**FINAL FINDINGS AND DECISION BY THE LANDMARKS COMMISSION RENDERED ON January 13, 2020**

**CASE FILE NUMBER: LU 19-207837 HRM**  
**PC # 18-279927**  
***New Duplex in Irvington***

**1 SITE PLAN**  
1/8" = 1'-0"

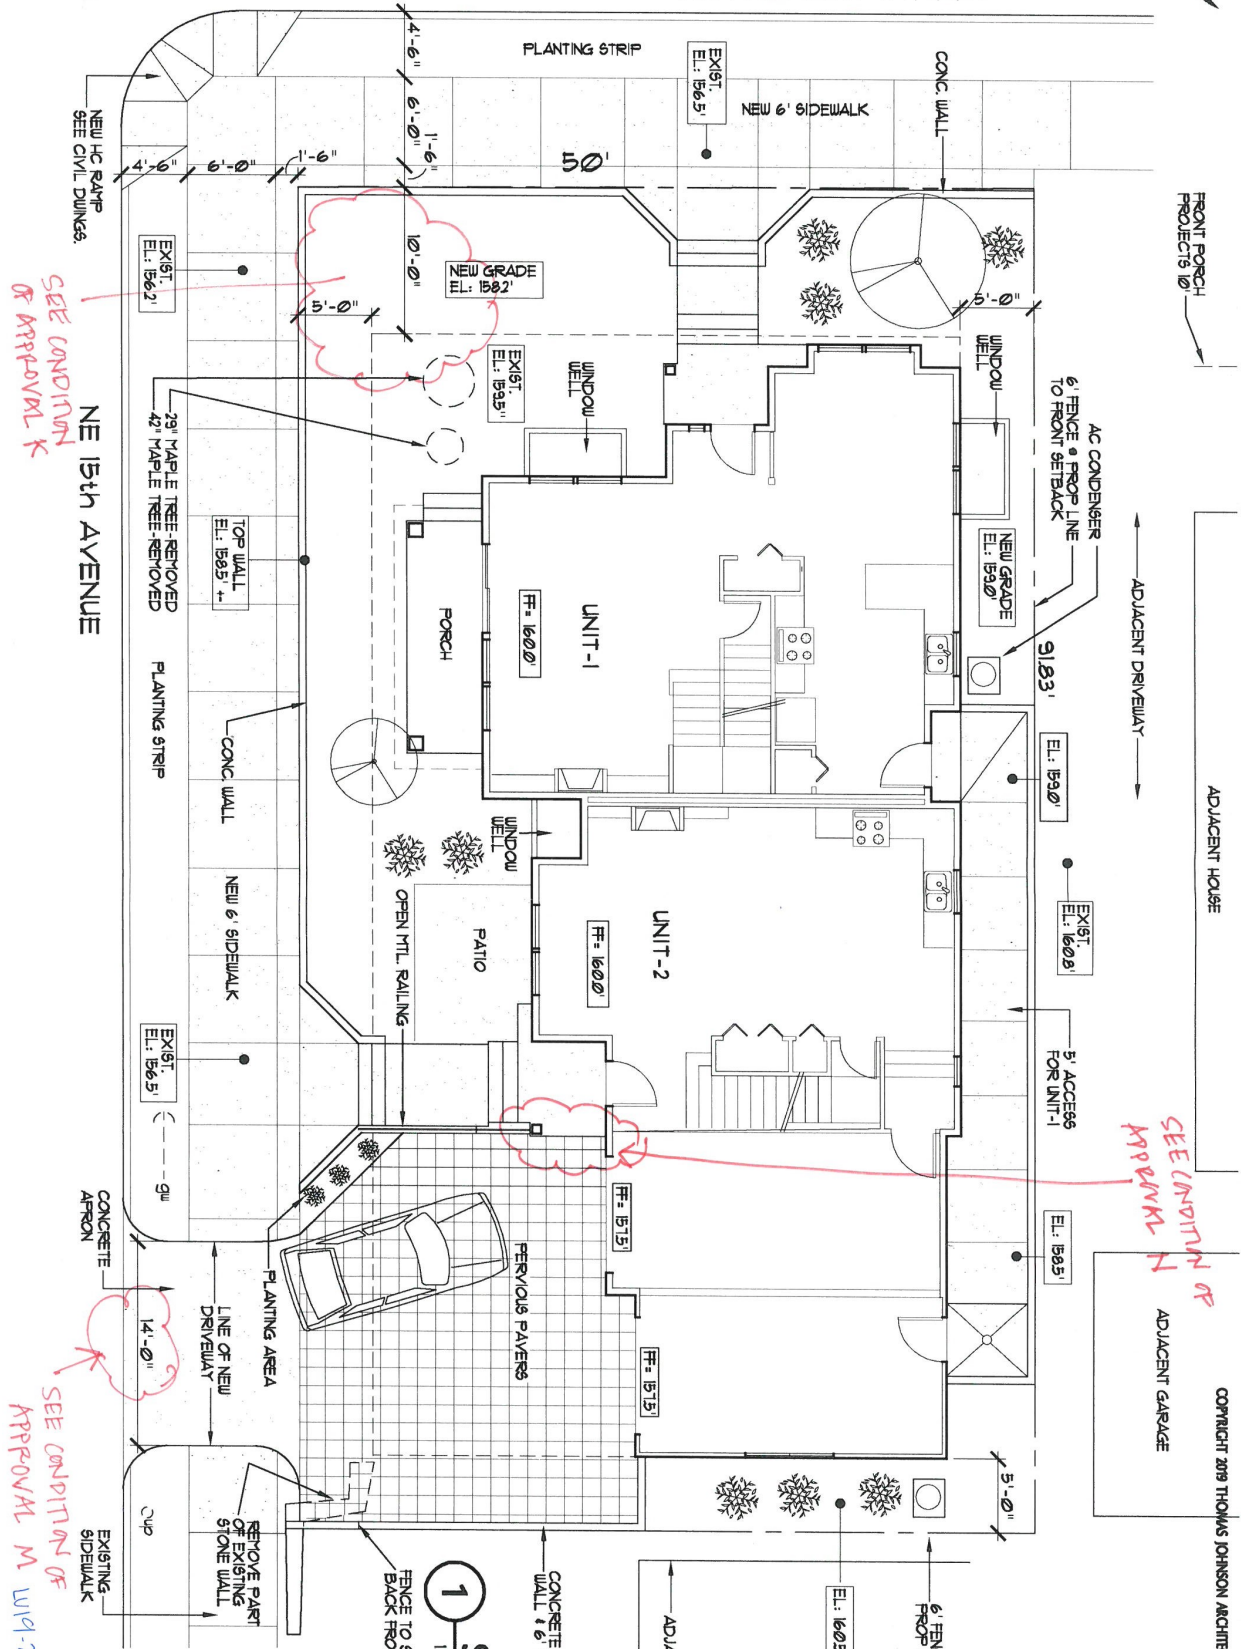
SEE CONDITION OF APPROVAL K

SEE CONDITION OF APPROVAL M W/19-207831 HR/C.1

SEE CONDITION OF APPROVAL N

- K. A large canopy tree, with a minimum mature height and width of 30' shall be planted at the northwest corner of the site.
- L. Second floor window type shall be double hung as shown on exhibit 13.A.
- M. The proposed driveway on NE 15<sup>th</sup> Avenue shall have a maximum width of nine feet. Any wider driveway shall require an approved driveway design exception review, to be approved prior to the issuance of a building permit.
- N. The south elevation view on sheet C.15 shall be revised to reflect a porch post at the entry, as shown on site plan C.1.
- O. No field changes allowed.
